**FIGURE R3.7.2-2**  
Existing Zoning Districts

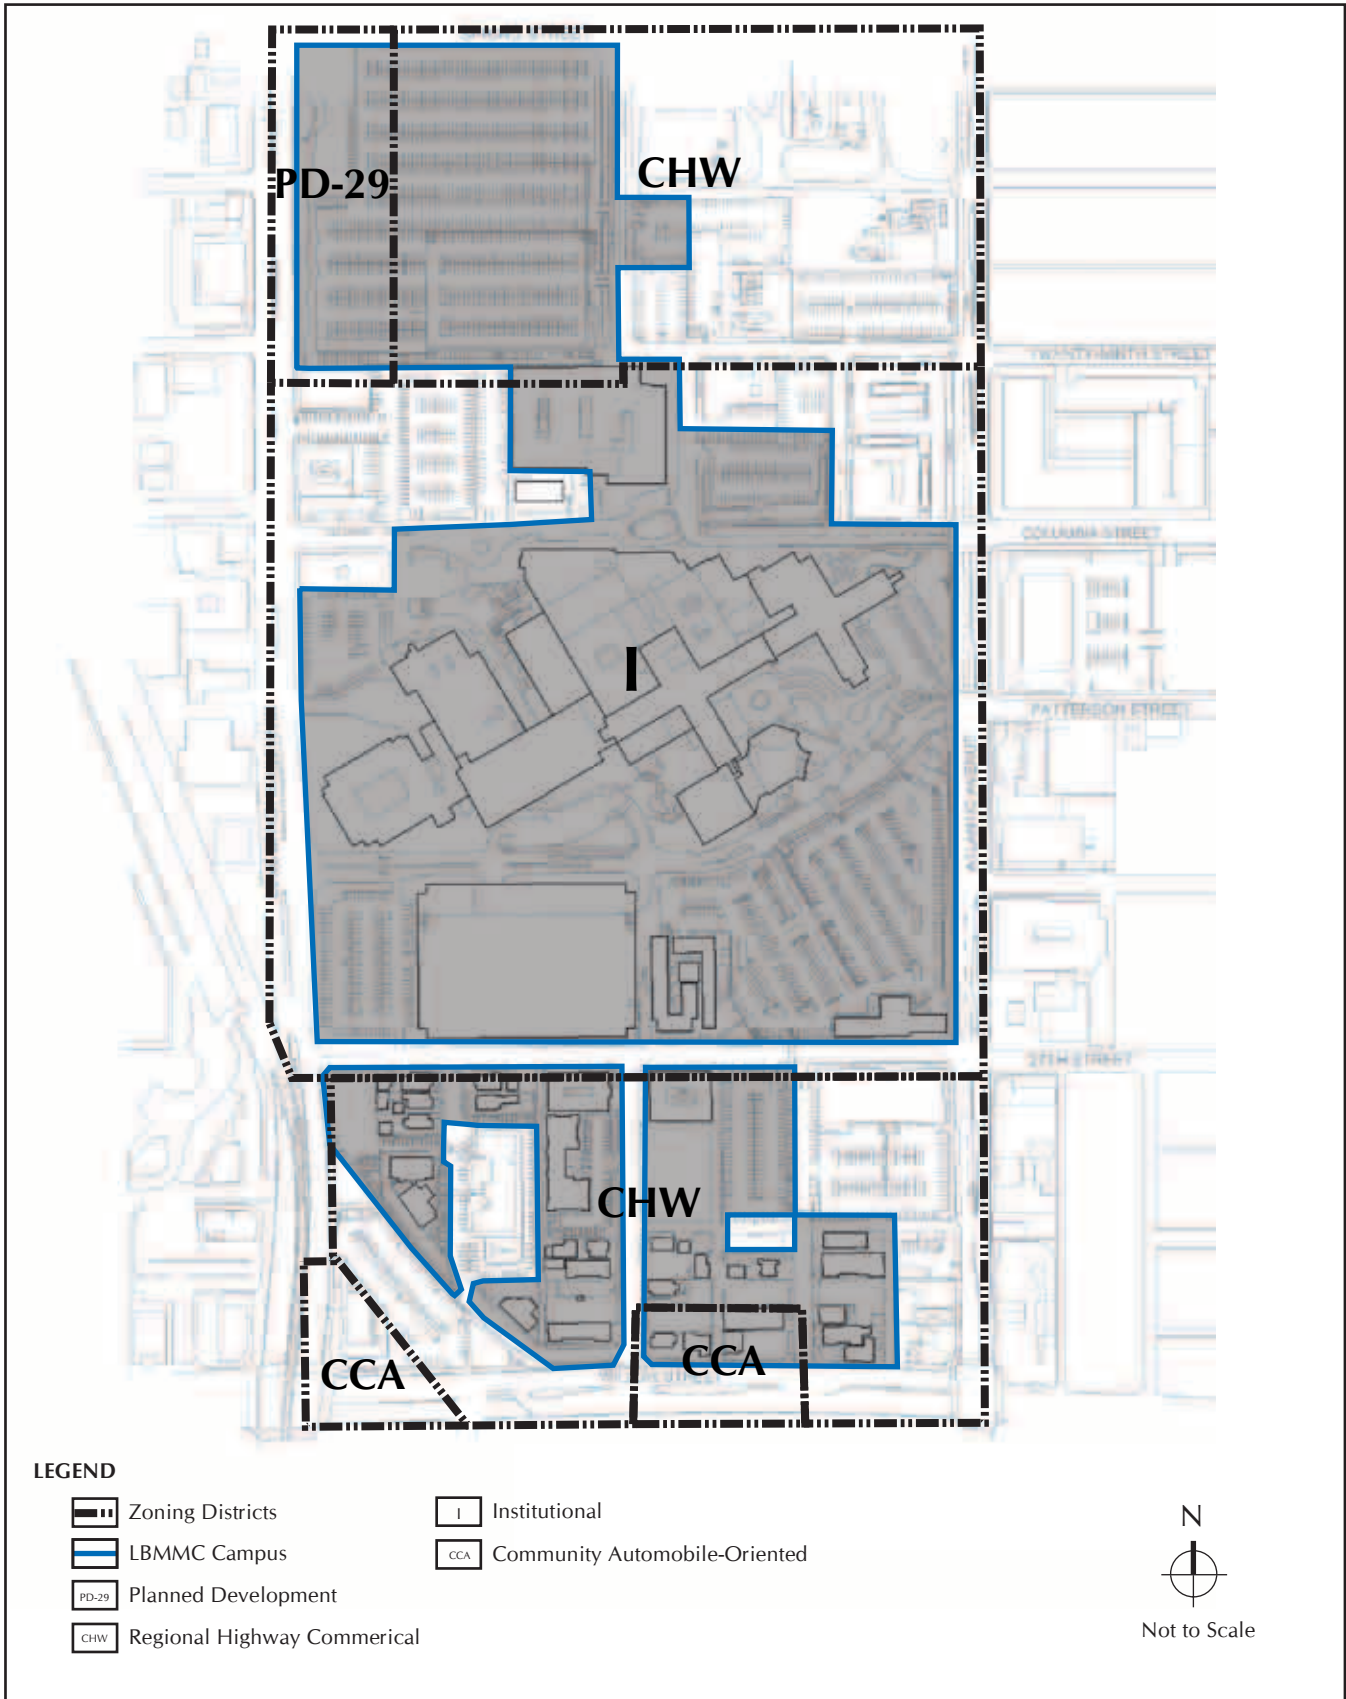
In the first sentence of the third paragraph under this heading, please replace the reference to (Figure 3.7.2-2, *Existing Zoning Districts*) with the following:

(Figure R3.7.2-2, *Existing Zoning Districts*)

**FIGURE R3.7.2-3**  
Long Beach Memorial Medical Center Parcels

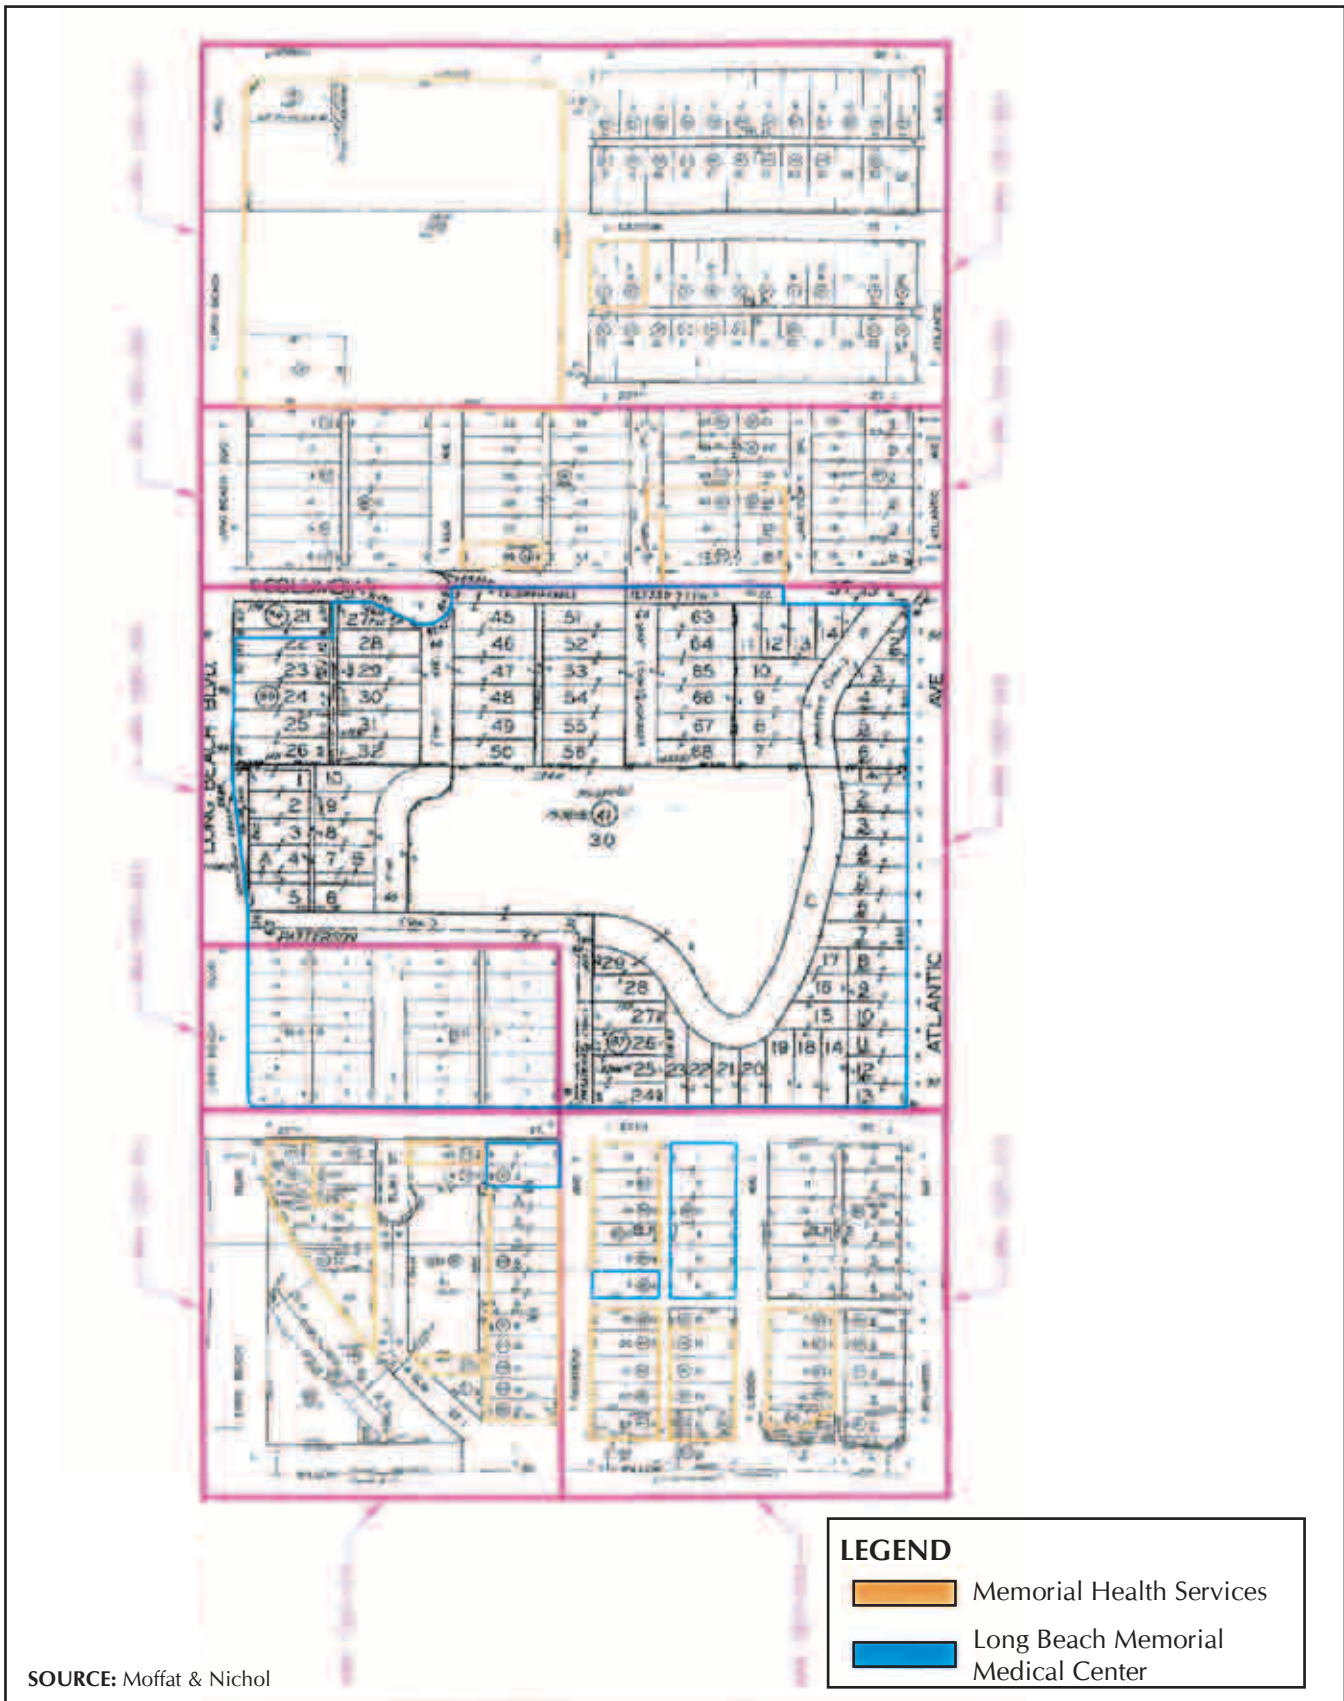
Page 3.7.3 Please insert the following sentence after the last paragraph under this heading:

The Campus is composed of a combination of parcels owned by Memorial Health Services (MHS) and LBMMC (Figure R3.7.2-3, *Long Beach Memorial Medical Center Parcels*).

**FIGURE R3.7.2-4**

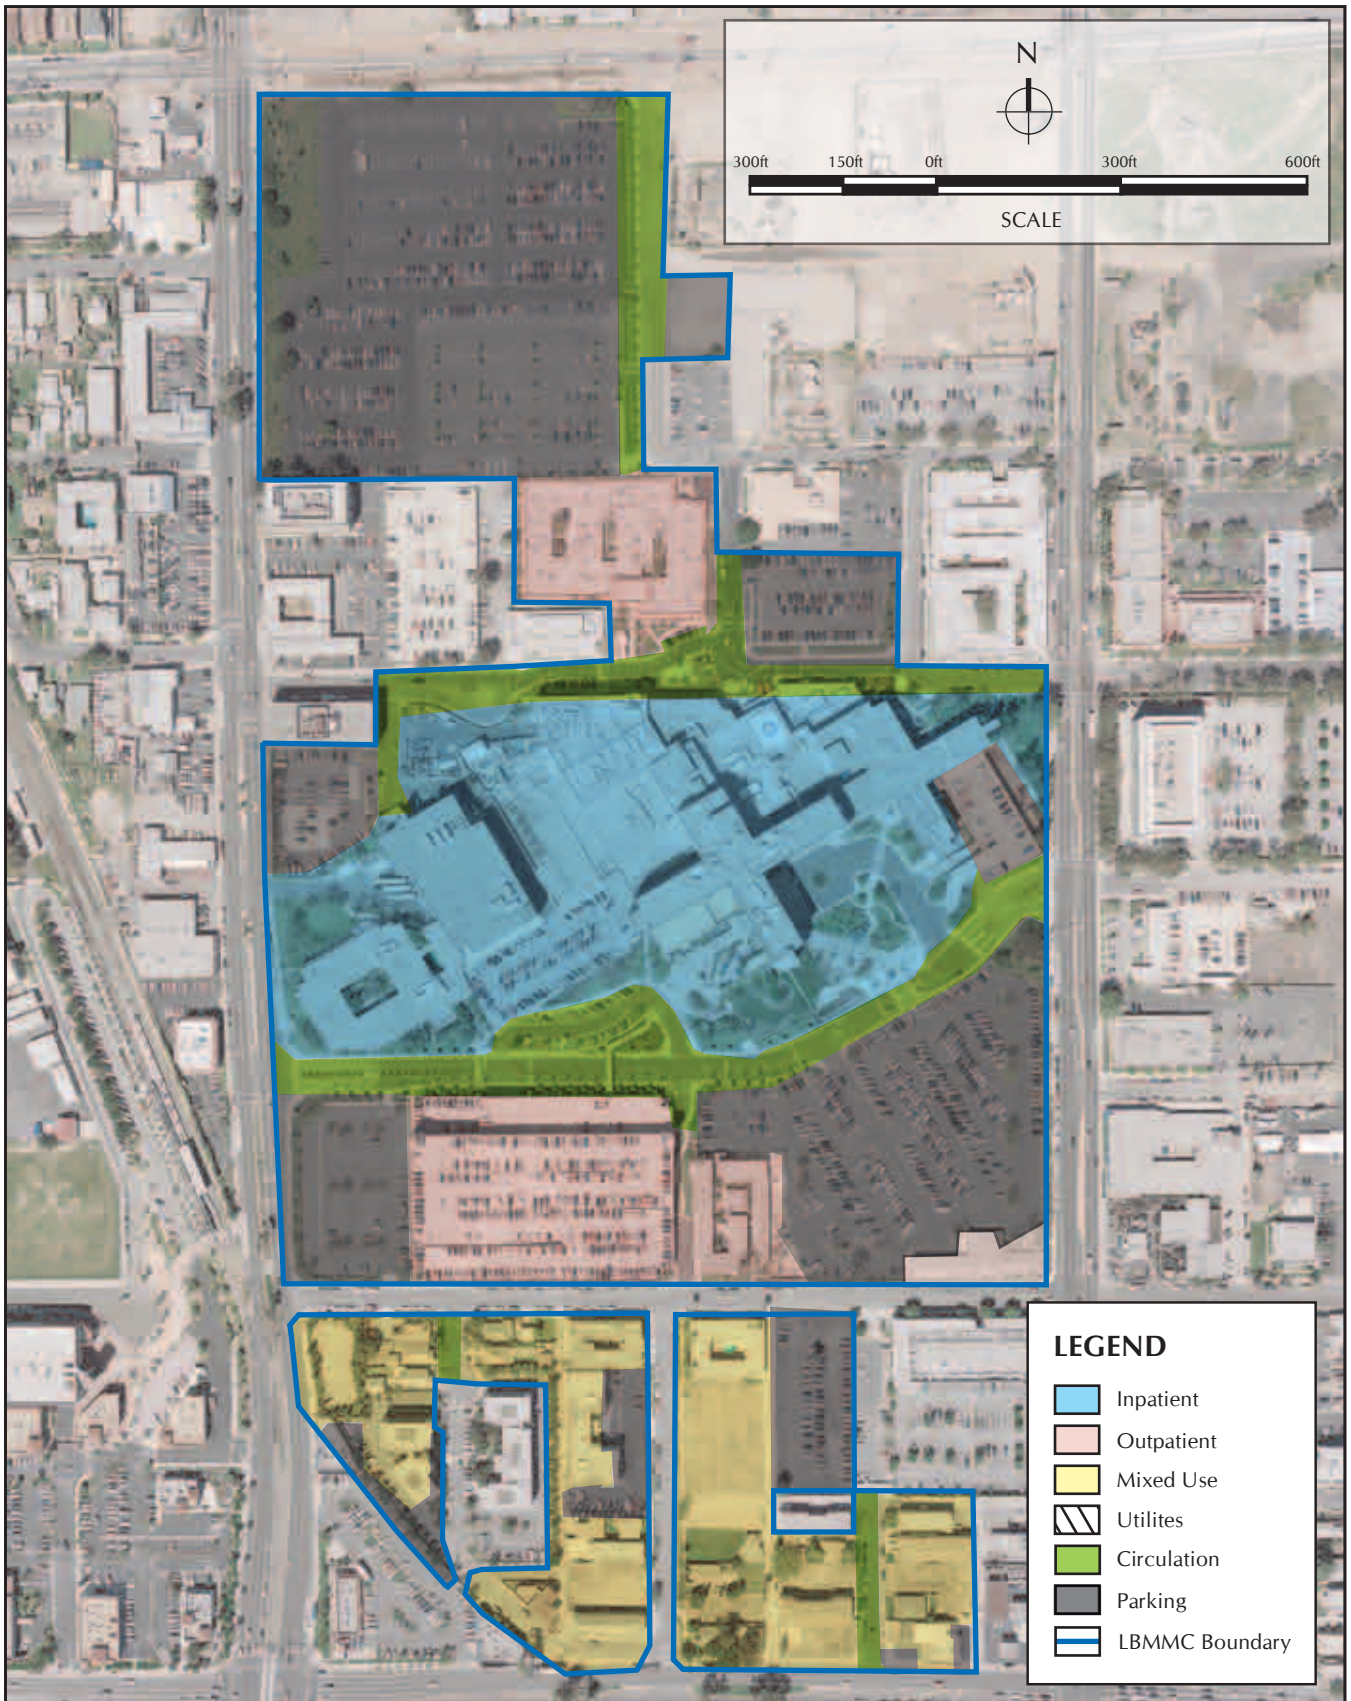
Page 3.7-3 The northeastern boundary of the Campus and the location of central plant building were revised in Figure 3.7.2-3 and replaced by Figure R3.7.2-4.

In the first sentence of the first paragraph under this heading, please replace the reference to (Figure 3.7.2-3, *Immediate Vicinity of the Long Beach Memorial Medical Center*) with the following:

(Figure R3.7.2-4, *Immediate Vicinity of the Long Beach Memorial Medical Center*)

**FIGURE R3.7.4-1**  
Proposed Zoning Districts

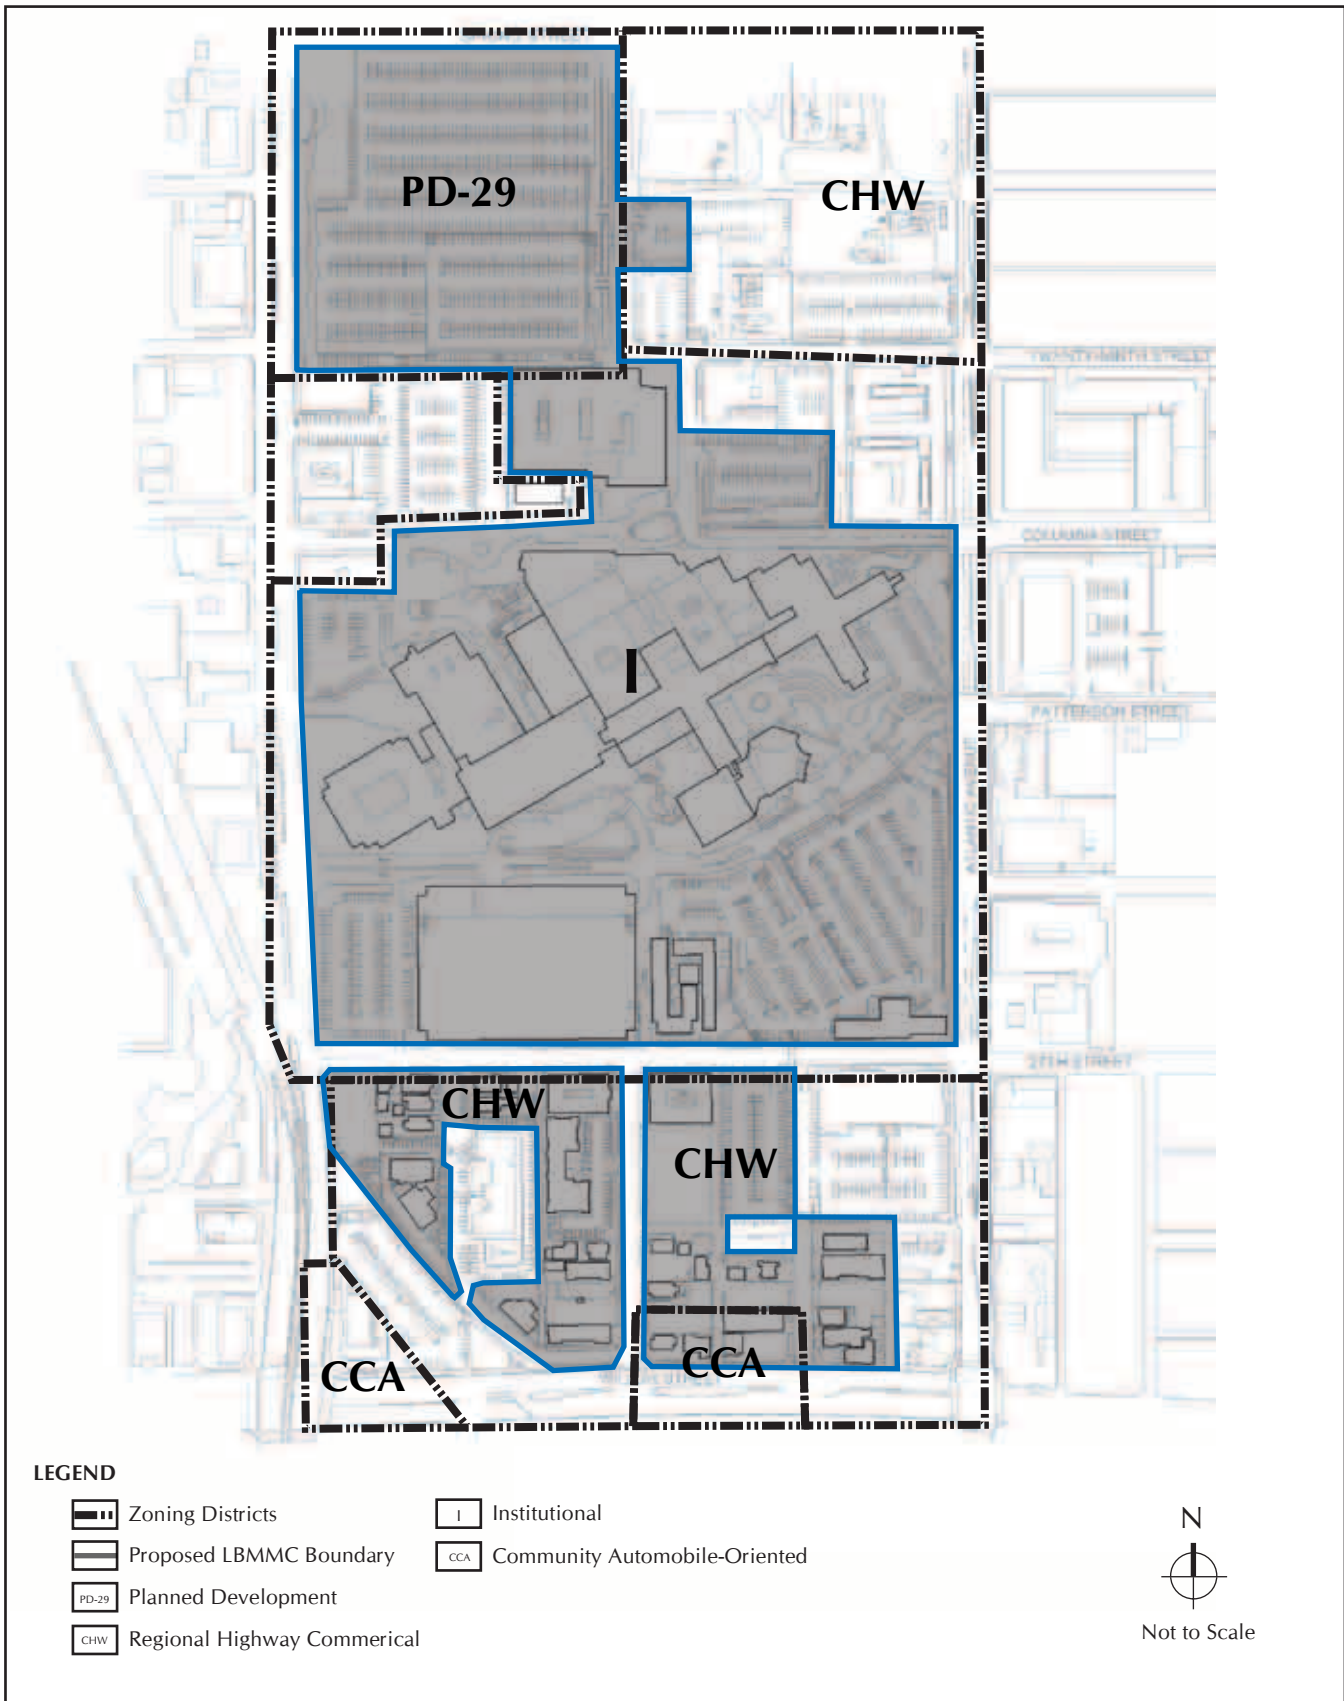
Page 3.7-7 The northeastern boundary of the Campus was revised in Figure 3.7.4-1 and replaced by Figure R3.7.4-1.

In the fifth sentence of the sixth paragraph under this heading, please replace the reference to (Figure 3.7.4-1, *Proposed Zoning Districts*) with the following:

(Figure R3.7.4-1, *Proposed Zoning Districts*)
